HISTORIC AND DESIGN REVIEW COMMISSION

March 06, 2019

HDRC CASE NO: 2019-095
ADDRESS: 1122 N PINE ST
LEGAL DESCRIPTION: NCB 1300 BLK 1 LOT 3
ZONING: R-5, H
CITY COUNCIL DIST.: 2
DISTRICT: Dignowity Hill Historic District
APPLICANT: Martin Da La Garza/Arki Design Homes
OWNER: Tarun Gajera/ADITYA GAJERA LLC
TYPE OF WORK: Front and Rear Additions
APPLICATION RECEIVED: February 18, 2019
60-DAY REVIEW: April 17, 2019
REQUEST:

EXISTING BUILDING REAR ELEVATION

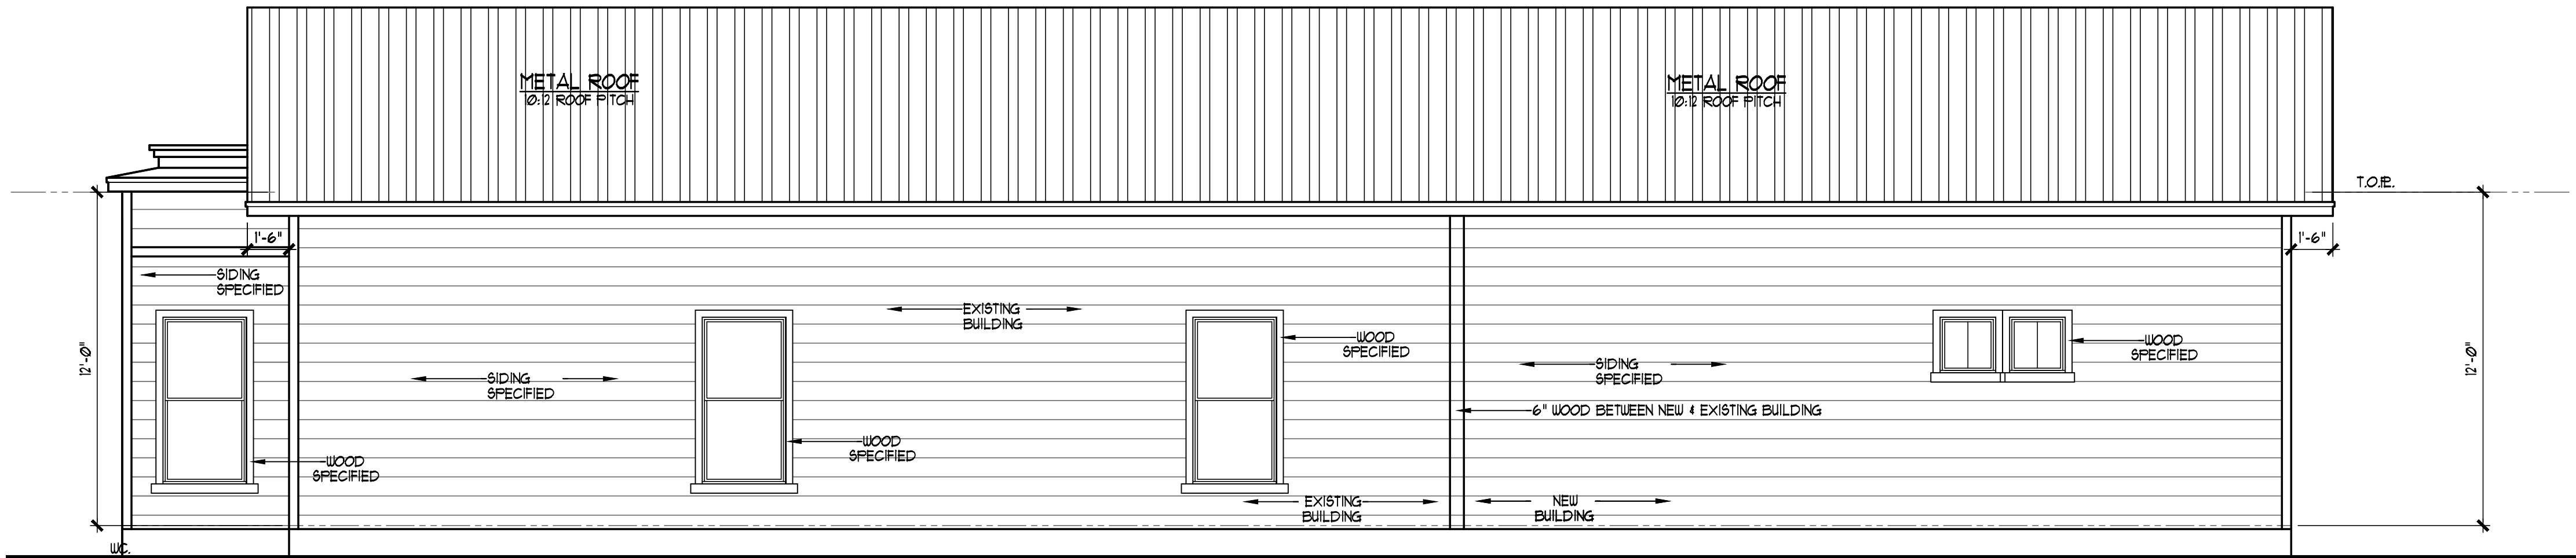
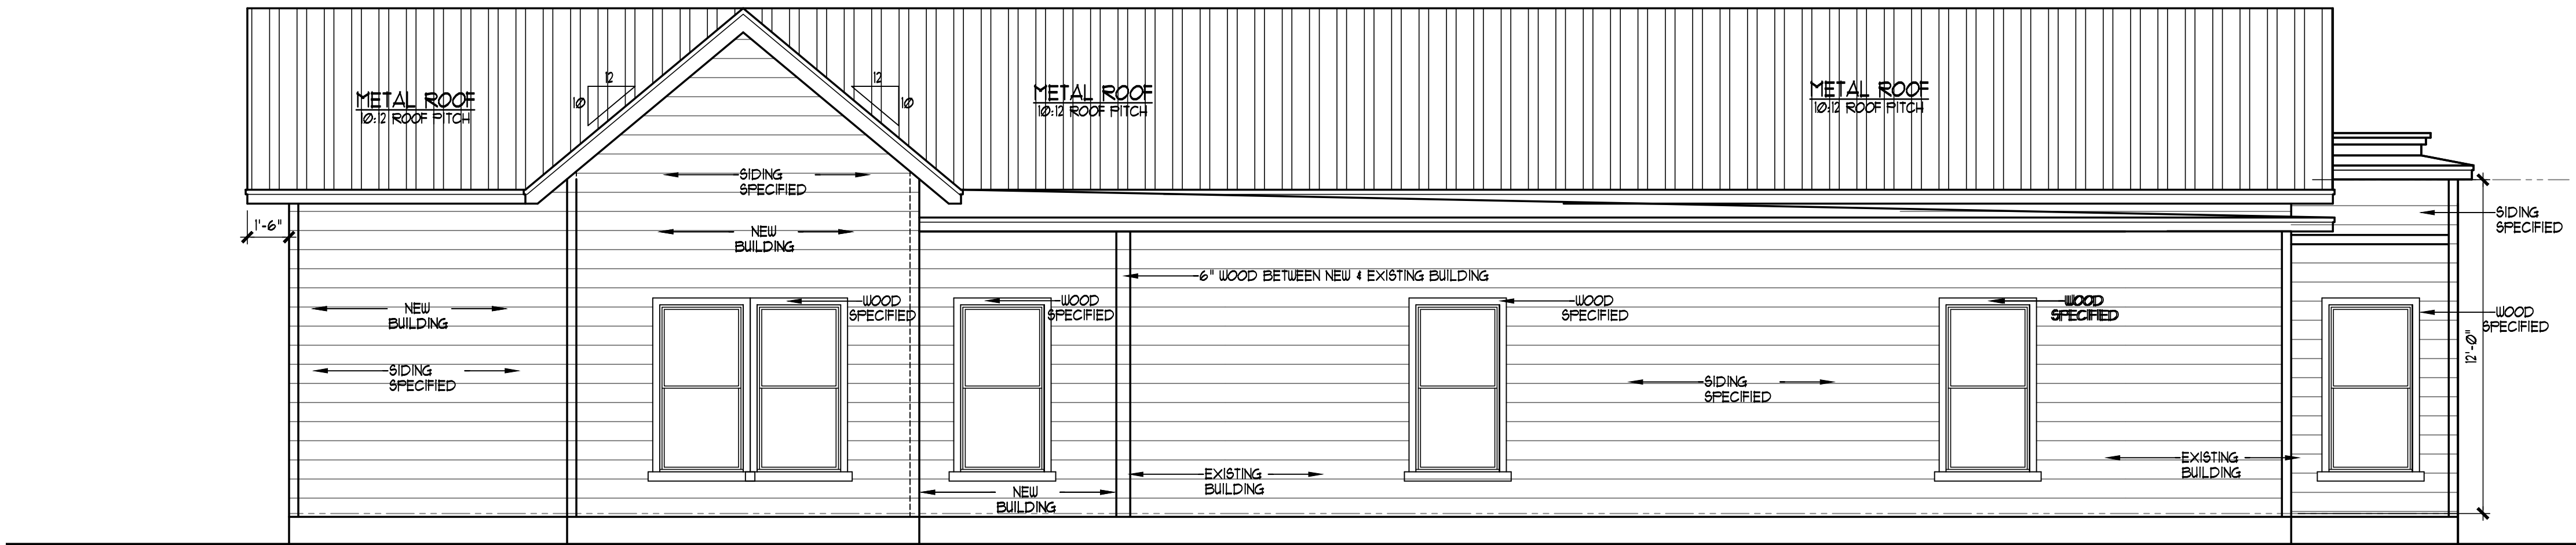
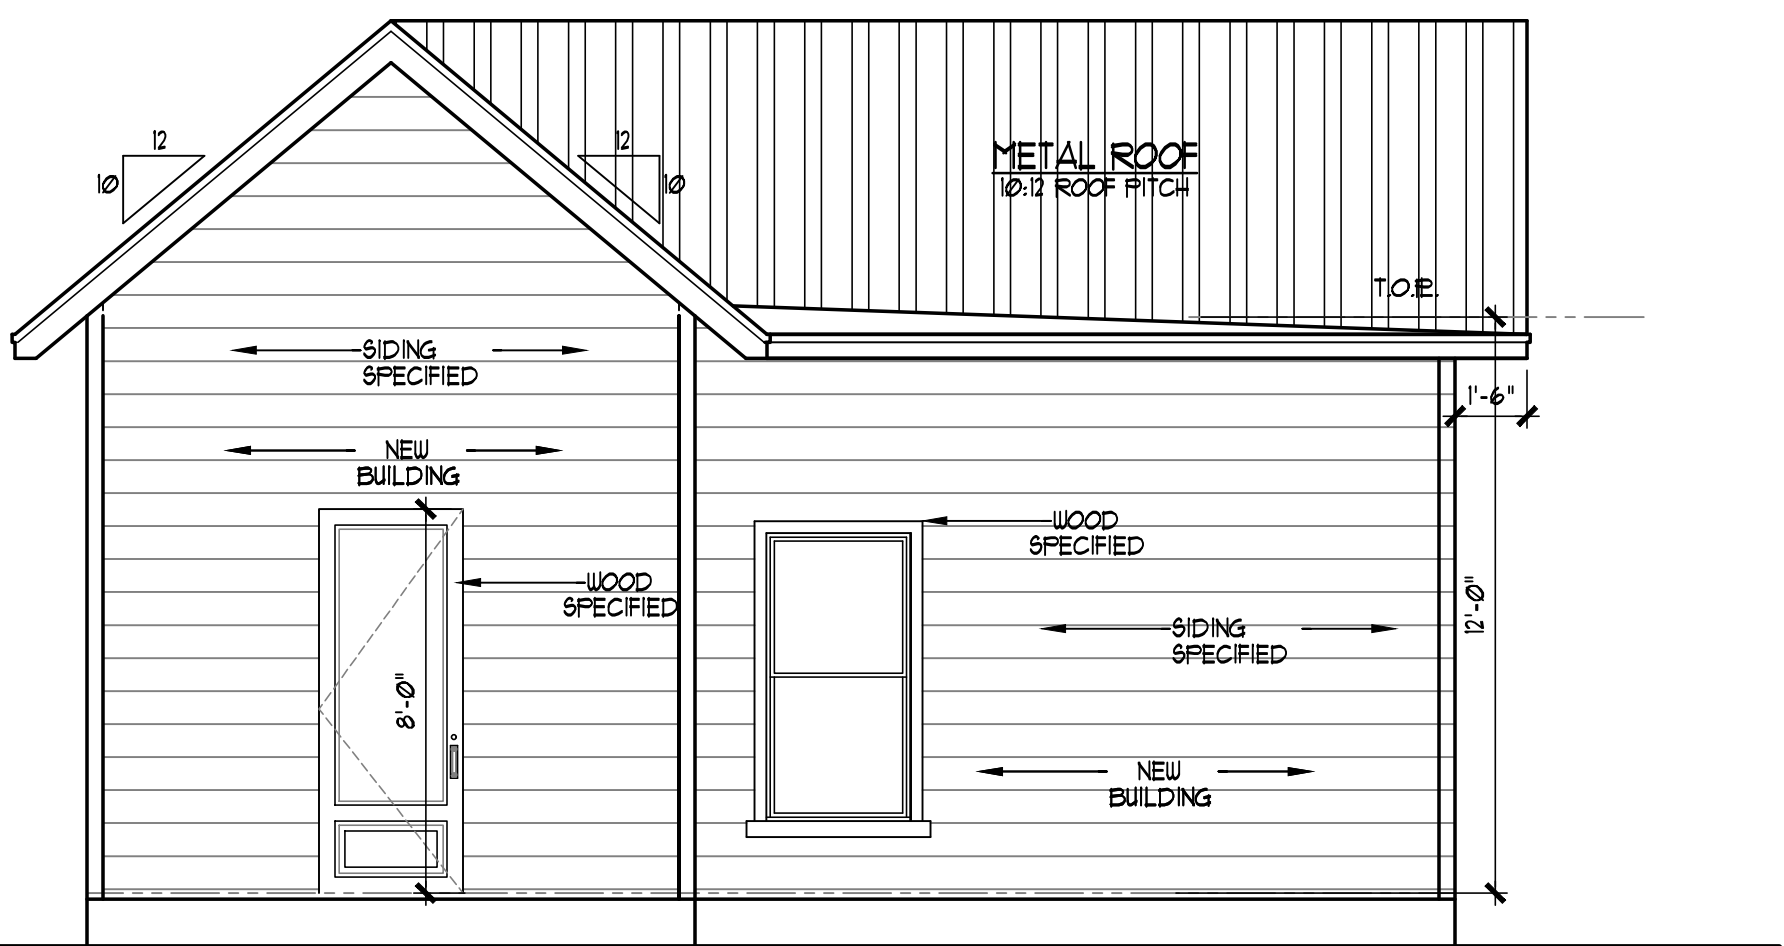
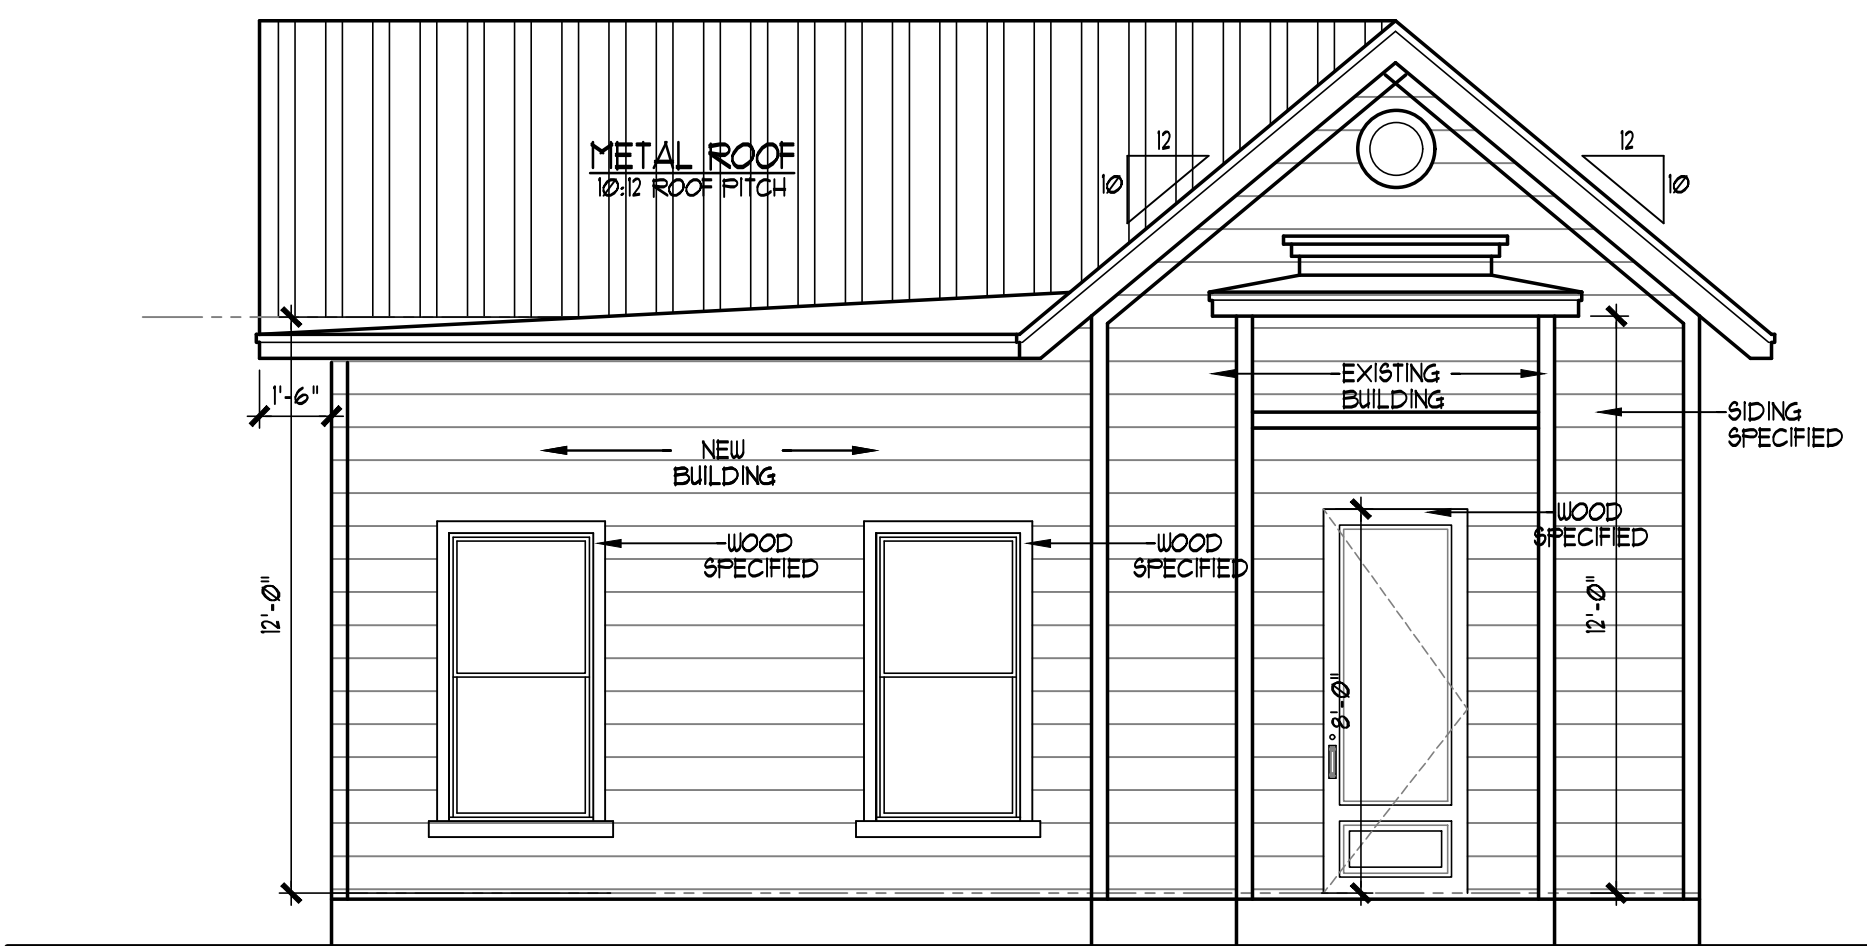
- e. TRANSITION BETWEEN NEW & OLD – The proposed rear addition features matching siding and roofing with a vertical trim piece to distinguish between new and old forms. Per the Guidelines for Additions, a setback or recessed area and a small change in detailing at the seam of the historic structure and new addition should be used to provide a clear visual distinction between old and new building. Staff finds that the proposed vertical trim piece as opposed to the setback condition would suffice in distinguishing between forms while preserving the linear configuration of the original front-facing gable.

Hardie in the same profile, configuration, and lap exposure as the existing siding; faux wood grain texture should not be used. Staff finds that the shake shingle on the rear gable should be preserved and relocated in a matching configuration to the addition's rear gable.

- i. **ROOF FORM** - The addition's roof should feature an extension of the primary front-facing gable with a shed roof extending from the turned gable. No portions of gabled roofing should be demolished. The shake shingles on the existing rear gable should be relocated to the addition's rear gable in the same configuration. A site plan including the proposed roof form should be submitted to staff.

- ii. **ROOFING MATERIAL** - The addition's roof should feature the standard specifications for new standing seam metal roofs: *18 to 21 inch wide panels, seams 1 to 2 inches tall, a crimped or double munch seam with no vented ridge caps, and a standard galvalume finish or painted to match the historic roof.* An inspection should be schedule with staff prior to installation.

- v. **SIDING** - The addition's siding should feature Hardie or wood siding that matches the existing in profile, configuration, and lap exposure. Faux wood grain texture should not be used.

SITE PLAN

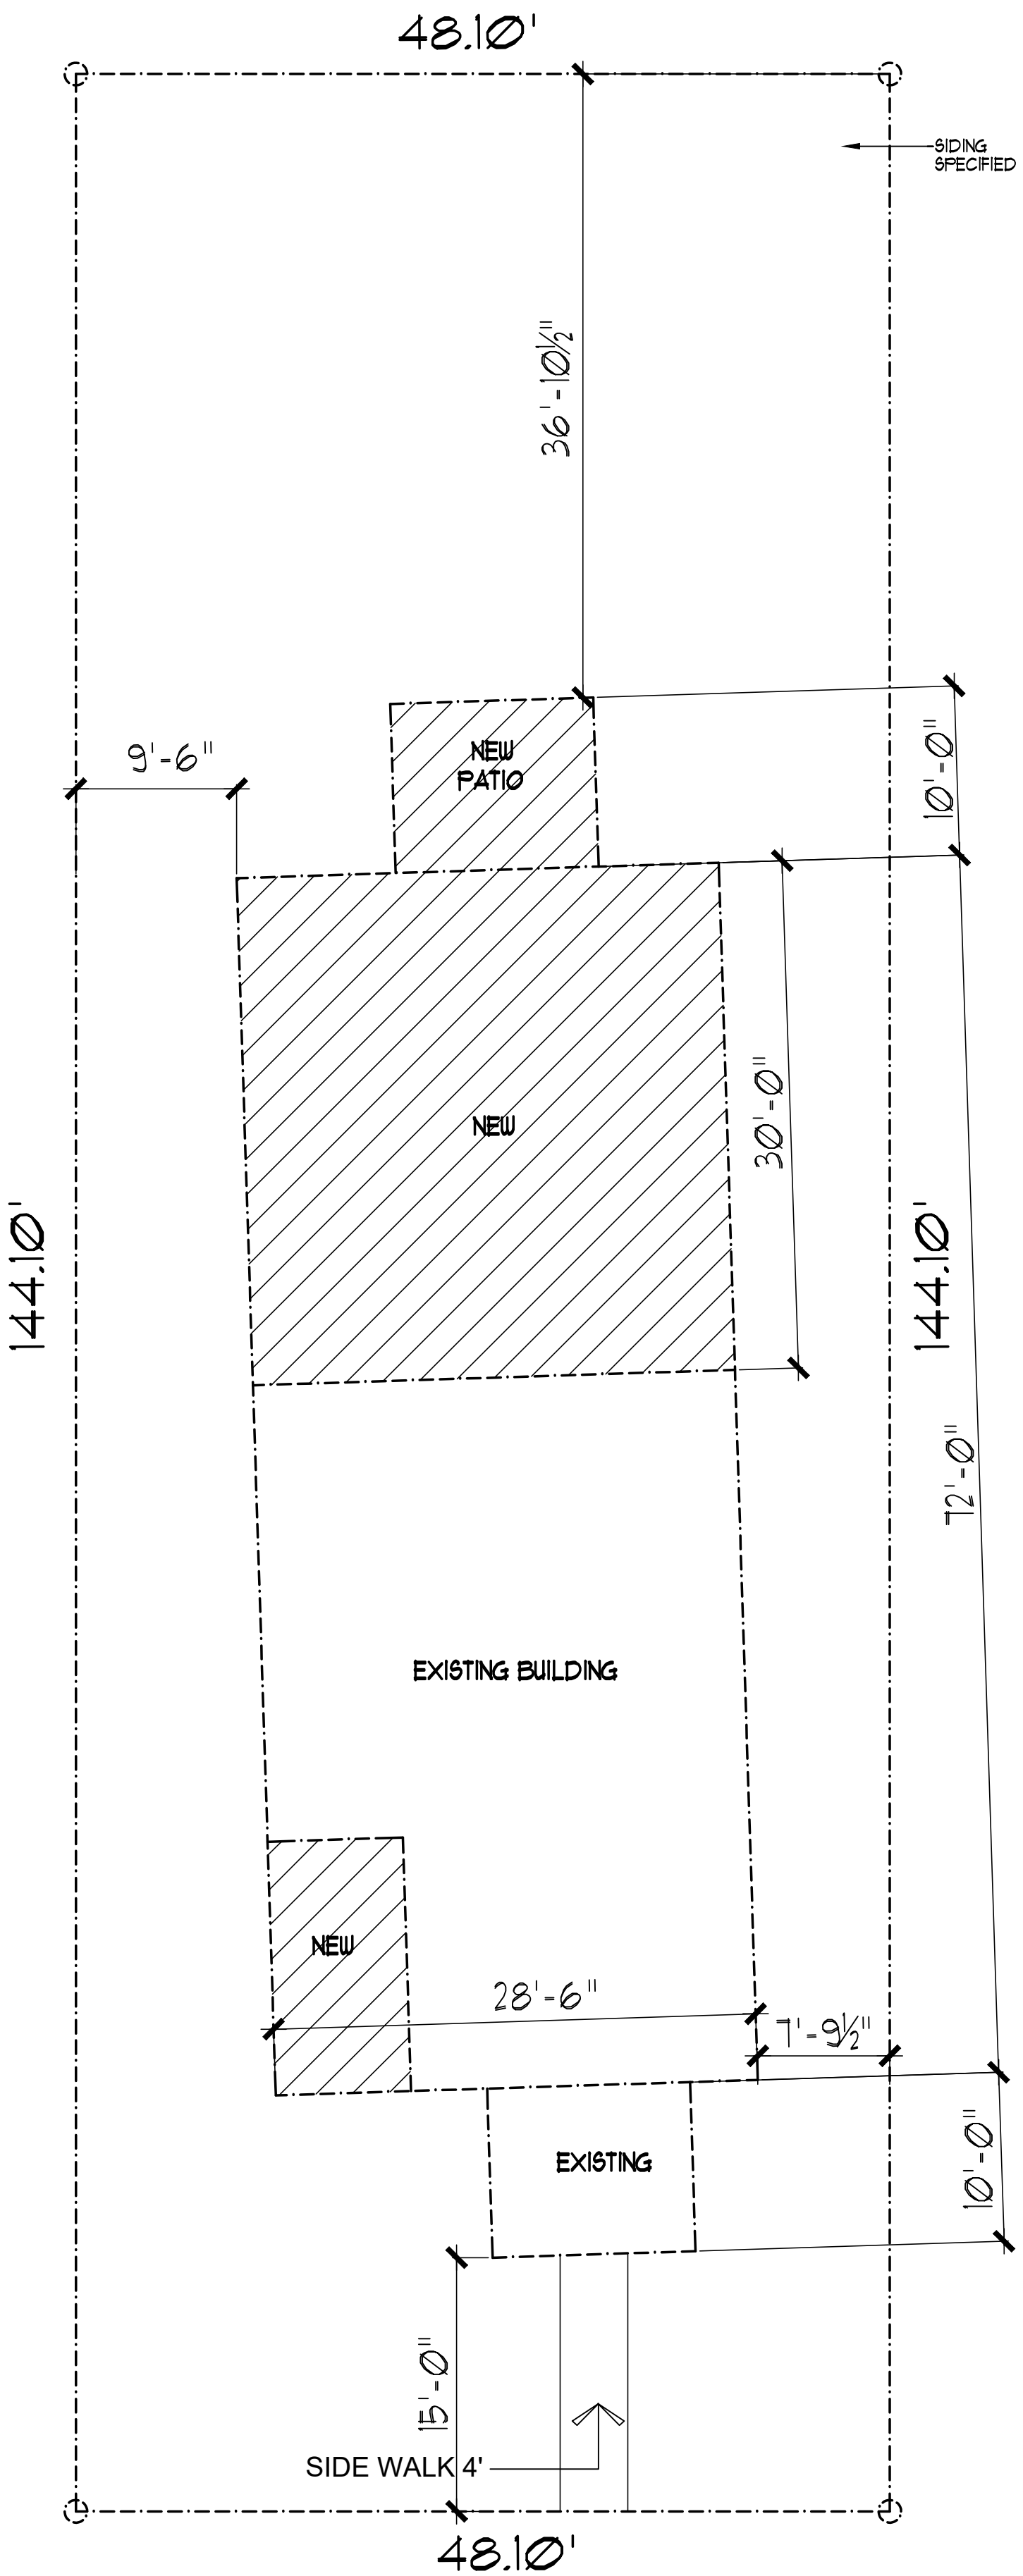
- b. FRONT ADDITION – The applicant has proposed to install a front addition featuring approximately 200 square feet by modifying the existing plan front porch enclosure into a rectangular room with a shed roof. Per the Guidelines for Additions 3.1.A., an addition to the front of a building would be inappropriate. Furthermore, staff finds that this structure's original L-plan was uncommon to the Folk Victorian configurations found in the historic district and is a character-defining feature that should be preserved. Staff finds that the enclosure non-conforming front porch should be repaired in-place or restored to its original open porch configuration.

1. Staff does not recommend approval of the front addition based on finding b. Staff recommends the applicant repair the non-original enclosed front porch in-place or restore the porch to its original open configuration with additional staff review.
